FIELD SERVICE BULLETIN

FSB Number: LVCCFSB2004-84 (Rev A)
 Author: Tony Bryan
 Date: May 19th, 2004
 Total No. of Pages: 3
 Subject: **GSM Triplets – Display Compatibility**
 Model Affected: GSM V300, V303, V400, V500, V525, V600
 Level of Repair: 3

Agilent Camera Markings (ADCM)

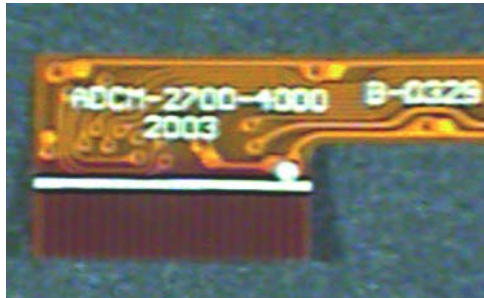
1. First, verify the phone model. Then, use the information provided above to determine which display module should be used for replacement.
2. Check to determine if the camera in the phone is an Agilent camera module (ADCM printed on the flex tail near connector). See image below for reference.
 - a. If Agilent, replace only with modules that support Agilent per chart above.
 - b. For all other cameras, existing display module stock may be used to depletion.
